Spartan Fire, LLC

Campaign Service Bulletin
CSB23-260-001

CONDITION: Changes based on new product testing to improve steering geometry and reliability.

CORRECTION: Replace steering assist cylinder bracket, officer side steering arm, and assist cylinder steering hose.

Figure 2.1

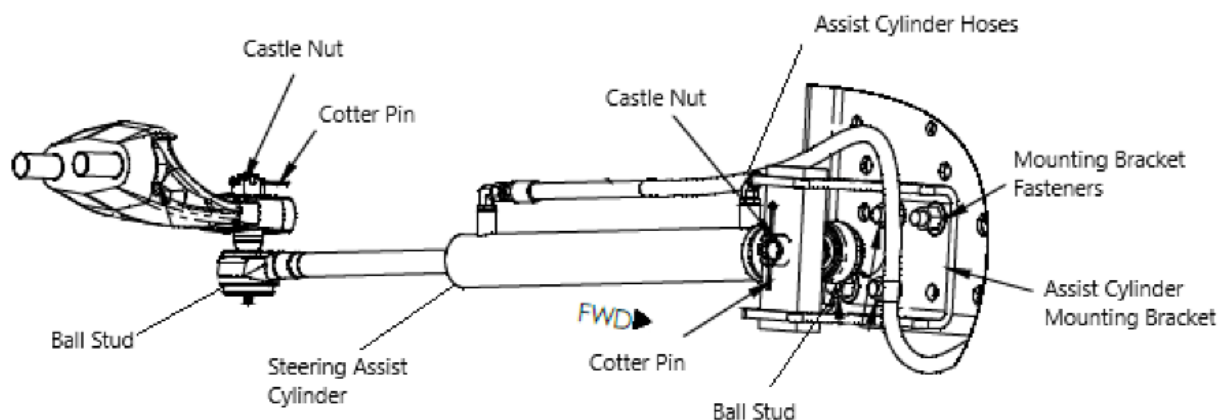
- 1) Remove steering assist cylinder and mounting bracket.
 - a. Remove assist cylinder hydraulic hoses. Label hose ends for proper reinstallation.
 - b. Remove cotter pins from each assist cylinder stud.
 - c. Loosen the castle nuts 4-5 turns.
 - d. Use appropriate puller tool to unseat the ball stud from the mount.
 - e. Once loosened from the mount, completely remove the castle nuts.
 - f. Remove the assist cylinder.
 - g. Remove the steering assist cylinder mounting bracket fasteners.
 - h. Discard steering assist cylinder mounting bracket.

Figure 3.1

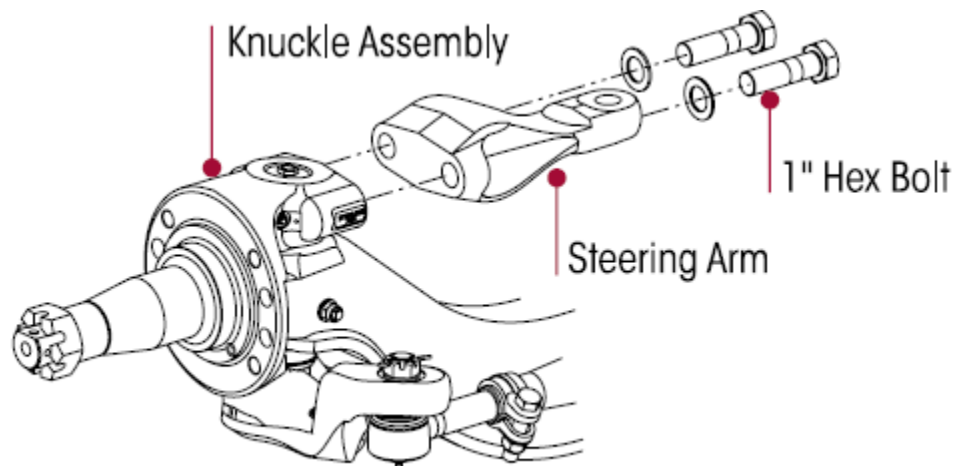
- a. Remove the two steering arm to knuckle hex bolts that hold the steering arm to the knuckle.
- b. Remove the steering arm from the knuckle. Gently tap the outside of the steering arm with a leather or plastic mallet if steering arm does not separate by hand.

Figure 4.1

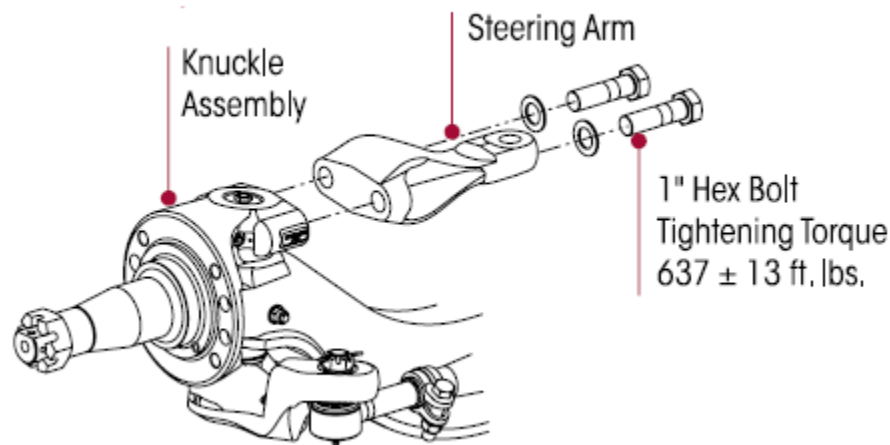
- Use a tap to remove old thread-locker compound from the internal threads in the steering knuckle.
- Use new steering arm hex bolts (pn: 30550-027) and new washers (pn: 22962-051). Coat at least half of the thread area with Loctite 680 adhesive.
- Insert the hex bolts through the new steering arm. Hand start the bolts into the knuckle assembly.
- Tighten the steering arm hex bolts to 637 ± 13 foot pounds torque.

Figure 5.1

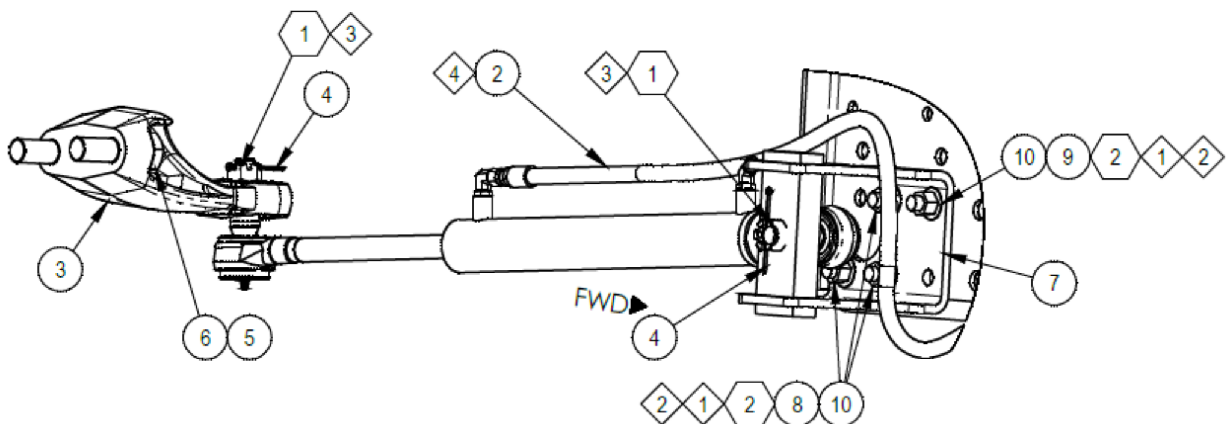
- 4) Reinstall assist cylinder and new bracket.
 - a. Install new steering assist cylinder bracket part number 3161-KK1-001 (Item 7) using new bolts (item 8-9) and new nuts (item 10). Install bolts hand tight. Do not torque until after the steering assist cylinder is installed.
Note: Bolt item 9 is longer and must be installed in the location noted in Figure 5.1.

- c. Torque each castle nut to 145 ft lbs. If castle nut slot does not align with the cotter pin hole in the ball stud initially, tighten nut slightly to align the slot with the hole. **Do not loosen to align the slot to the hole.**

- d. Install cotter pins through castle nut and ball stud and bend cotter pins over.
 - e. Torque the new 5/8" diameter bolts in new steering assist cylinder bracket to 201 ft lbs.

1 DO NOT REUSE FASTENERS. THEY ARE TORQUED TO 90% PROOF. 2 ASSIST CYLINDER NEEDS TO BE INSTALLED BEFORE BRACKET IS TORQUED. 3 CONTINUE TIGHTENING, DO NOT BACK OFF, TO ALIGN THE NUT SLOT WITH THE COTTER HOLE TO PERMIT ASSEMBLY OF THE COTTER PIN. 4 REFER TO SPARTAN P/N 0208-BB1 FOR ALL FITTING INSTALLATION SPECIFICATIONS.			
1	TORQUE	RANGE (OZ)	DRIVE SIDE
	145 LB-FT	120-170	NUT
2	TORQUE	RANGE (OZ)	DRIVE SIDE
	201 LB-FT	192-212	NUT

Figure 6.2

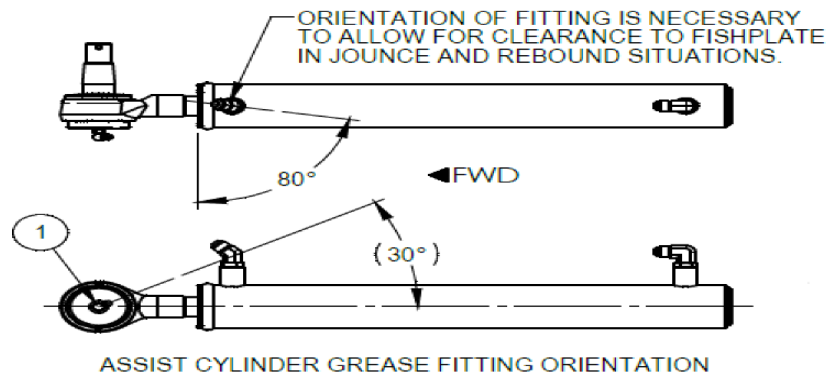
- b. Install 90° grease zerk (0346-BB1-001) into frame mounted end of assist cylinder, oriented as shown in Figure 6.2. Reinstall steering assist cylinder ball studs into new mounting bracket and steering arm. Install castle nuts snug.

- f. Verify correct orientation of fittings on the assist cylinder before reconnecting hoses. *See Figure 6.2*

Figure 7.1

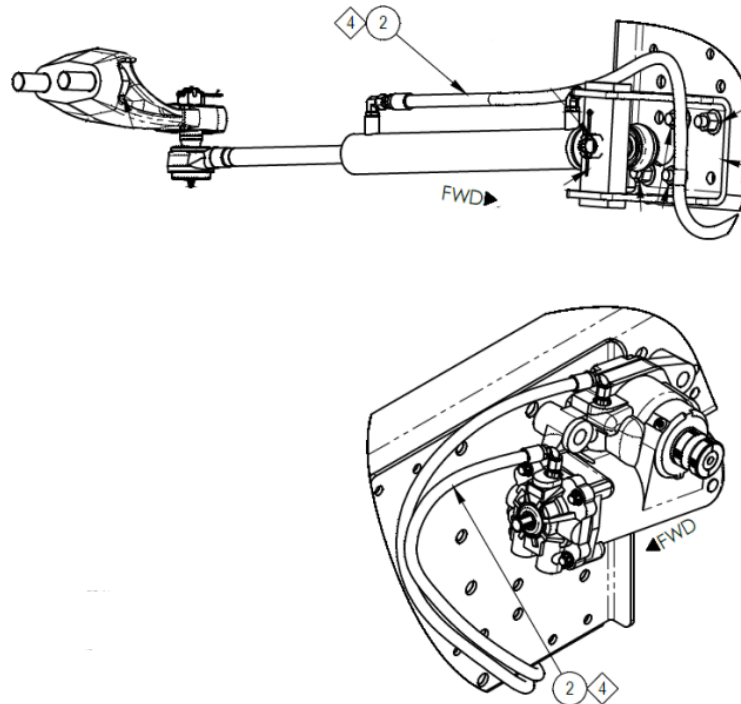
- g. Reconnect hydraulic hoses to assist cylinder, noting proper port orientation per labels installed in step 1a. Replace hose plumbed to rear assist port with longer hose to improve routing (06W-06JA06JB108). Also, refer to *Figure 7.1* below for proper hose orientation.
